ARLINGTON COUNTY, VIRGINIA

County Board Agenda Item
Meeting of October 24, 2009

SUBJECT: SP #106 SITE PLAN AMENDMENT for amendment to Shirlington Comprehensive Sign Plan for Shirlington Hotel; 4271 Campbell Ave. (RPC #29-014-021).

SIGN A ½"=1'-0"

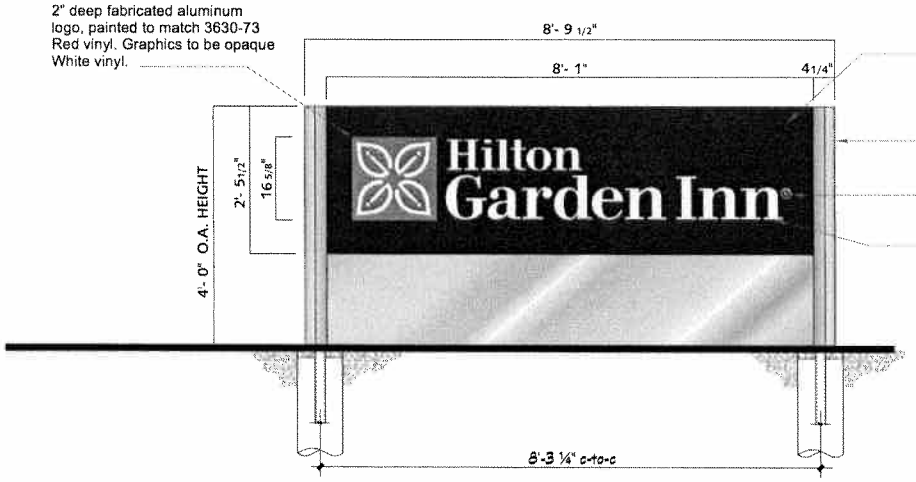
It is not typical County practice to allow free-standing signs in walkable, urban areas such as the Rosslyn-Ballston Corridor, the Jefferson Davis Corridor, or Shirlington due to the generally auto-oriented nature of these signs. However, staff supports the applicant's proposal for the free-standing monument sign because the proposed location is the only reasonable alternative for minimizing the lighting impact to adjacent residences. The intent of a sign on the northwest side of the building is for cars driving east on Arlington Mill Drive to be able to spot the hotel from that direction. It is also the most convenient location for a sign to direct drivers to the parking garage. Furthermore, since many hotel customers arrive during nighttime hours, the sign would need to be lit. As the County Board did not approve the applicant's request for a rooftop sign on the Campbell Avenue façade when Site Plan #106 for Shirlington Hotel was considered due to concerns about lighting from the Village at Shirlington Condominium residents, the County Board directed the applicant and staff to explore options for a lighted sign on the northwest side of the building that would not impact the adjacent residents.

While the County Board specifically mentioned a monument sign at this location, staff explored alternative options to a free-standing sign for the Shirlington Hotel. A wall sign on the Arlington Mill Drive façade would not have been feasible due to the approved landscaping blocking the visibility of any such sign from the street. Likewise, a wall sign (below 35 feet) on the Campbell Avenue façade would not have been feasible because the lighting would likely impact the adjacent residences. Moreover, any sign below 35-feet on this façade would have had limited visibility for customers traveling east on Arlington Mill Drive. Therefore, the only feasible option for a lighted sign on the northwest portion of the Shirlington Hotel site that would not impact adjacent residences would be a monument sign placed in the hotel's landscaping strip and facing Arlington Mill Drive.

Both the Fairlington-Shirlington Neighborhood Representative and the Shirlington Village Condominium Board President indicated to staff that their main concern with the proposed site plan amendment would be lighting impacts to the adjacent Shirlington Village Condominiums. The only sign that is proposed to have lighting is the monument sign. Due to the proposed sign being only 4-feet high, and because it would mainly face Arlington Mill Drive, there will not be a lighting impact to the Shirlington Village Condominiums.

8. The applicant agrees to install a rheostat or other appropriate variable resister that will allow the applicant to reduce the monument sign's lighting intensity. The applicant further agrees that if the County Manager finds that the intensity of the monument sign's lighting has an adverse effect on the surrounding area, the applicant will, within 24 hours notice from the County Manager, reduce the intensity of the lights to a level that, in the County Manager's reasonable judgment, will no longer have such an adverse effect.

10. The applicant agrees that the subject monument sign approved in this site plan amendment is intended as a replacement for one (1) rooftop sign otherwise allowed under the *Sign Guidelines for Site Plan Buildings*. The applicant further agrees that no additional rooftop signs shall be allowed for the Shirlington Hotel building at 4271 Campbell Avenue—with the exception of the rooftop sign for the Randolph Street façade approved by the County Board on January 24, 2007—unless the monument sign is first removed.

6. The applicant agrees to limit all signs to the size, design, location, color, materials, and text of the proposed signs shown on the drawings prepared by Chandler Signs, for Hilton Garden Inn and dated October 14, 2009. The applicant agrees that the total sign area allowed excluding rooftop signs will be no more than 30 square feet. The applicant agrees that the monument sign shall be illuminated only as shown on the drawing.

SIGN B 1" = 1'-0"

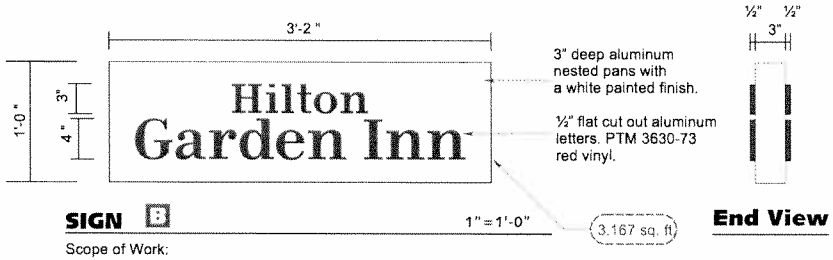
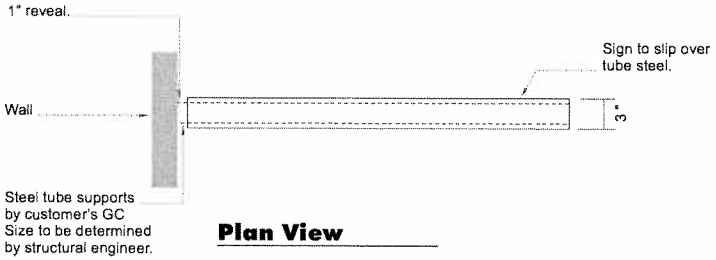
The signs proposed are consistent with Comprehensive Sign Plan and Sign Guidelines for the Village at Shirlington approved by the County Board in February 2005. The proposed blade sign to be located above the Campbell Avenue entrance to the hotel is consistent with the guidelines for such signs in that it is at least 8 feet in height (the sign is 12 feet above grade), does not project more than 42 inches from the building façade, and is less than the maximum 6 square feet allowed. The four (4) window logos (two on the doors at each entrance) are consistent with the approved Comprehensive Sign Plan in that they do not take up more than 20% of the window

SIGN 3 1"=1-0"

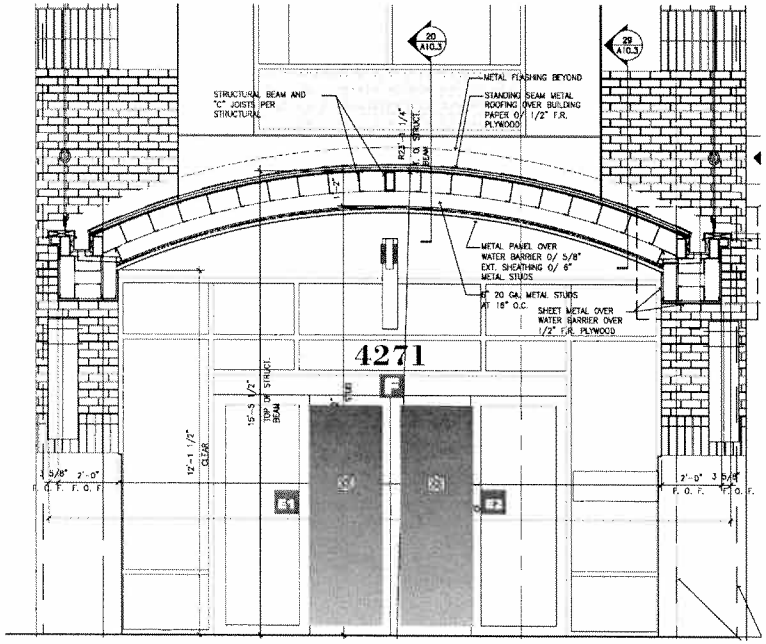
space on the doors on which they are proposed. The address indicator sign proposed is consistent in that it is located above the main entrance to the hotel on Campbell Avenue, and is visible for both vehicular and pedestrian traffic.
